AUDIT SUMMARY REGARDING THE LICENSE RENEWAL APPLICATION FOR THE SHEARON HARRIS NUCLEAR POWER PLANT, UNIT 1

VI. STAFF'S AUDIT QUESTIONS AND APPLICANT'S RESPONSES

**Attachment 1 - Question and Answer Database For AMR and AMP Reviews
Audit and Review Related to the License Renewal Application for
Harris Nuclear Power Plant**

consistent with the Code analysis. The resulting stress history is illustrated in Figure 1 on the next page.

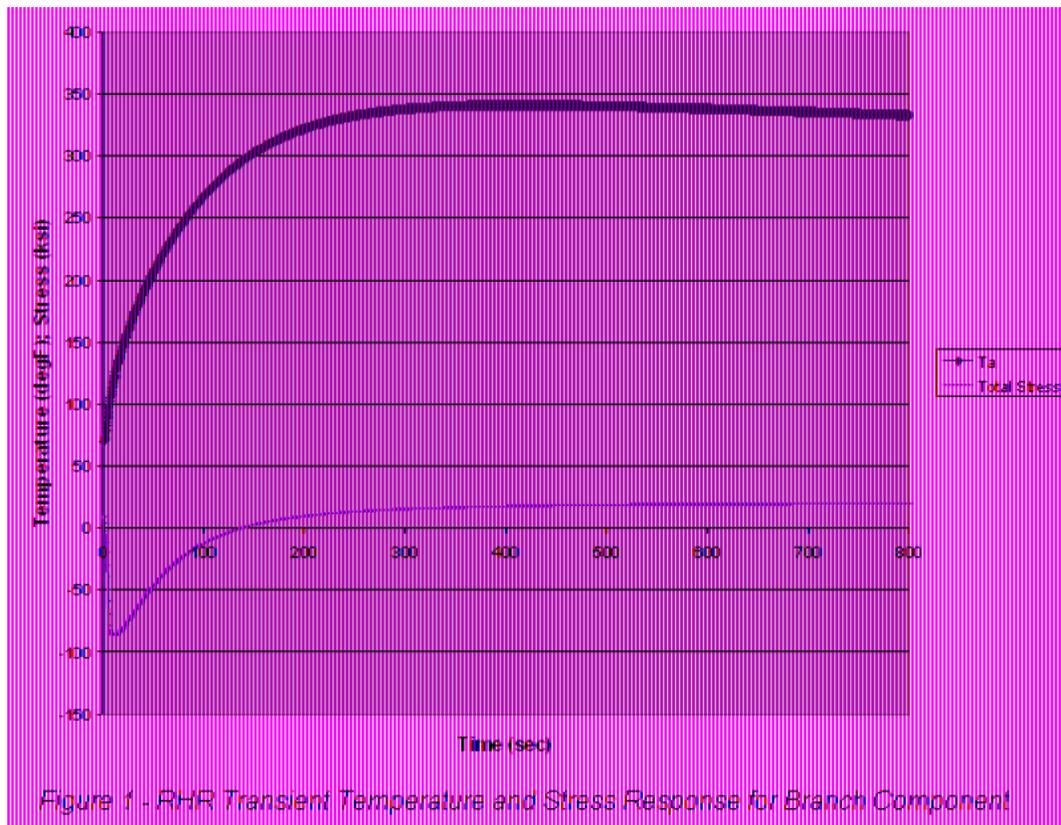
To address the question regarding the effect of the pressure and moment stresses on the total stress and resulting Fen, a detailed time history of the stress during the full RHR transient cycle was developed for the 12" x 1" branch component. The stresses were calculated consistent with the HNP design basis inputs and NB-3600 evaluation methodology. Applicable thermal transient, moment, and pressure histories were applied representing the RHR system design transient in the section of the RHR line containing the branch connection. The transient temperature goes from ambient conditions, at 70°F, to 350°F simulating the initiation of RHR flow through the otherwise isolated section of piping. The design transient description also assumes after the transient that gradual cooling of the system occurs at 100°F/hr, which was considered to represent negligible stress in the design. The RHR flow is initiated by design at approximately 425 psig system pressure. Therefore, a pressure load of 450 psia was used in the calculation. The moment stress from the piping design analysis of the branch was realistically ramped over the transient as a function of the pipe temperature. Pressure and moment stresses were considered only as tensile. The thermal stresses were appropriately signed to represent the inside wall stress in response to the thermal transient. The stresses were adjusted with the branch stress indices

This demonstrates that for the significant part of the transient history, the component is in the compressive state on the inside surface where environmental effects may be applicable. For this reason, in the initial estimation of environmental effects on this component, it was judged that environmental effect would be small and $F_{en} = 1.0$ was applied. However, the time history shown does include some periods where stress is in the tensile regime due to the pressure and moment

This should be applied to the usage calculated from the stress pair formed from the stress peaks represented by the minimum stress state (maximum compression) and the maximum stress state (maximum tension) of the transient. The total stress range in Figure 1 is approximately 102 ksi. Using the ASME design fatigue curve for stainless steels, this corresponds to approximately 1680 allowable cycles. For 200 design cycles of the RHR transient, the usage factor is 0.12.
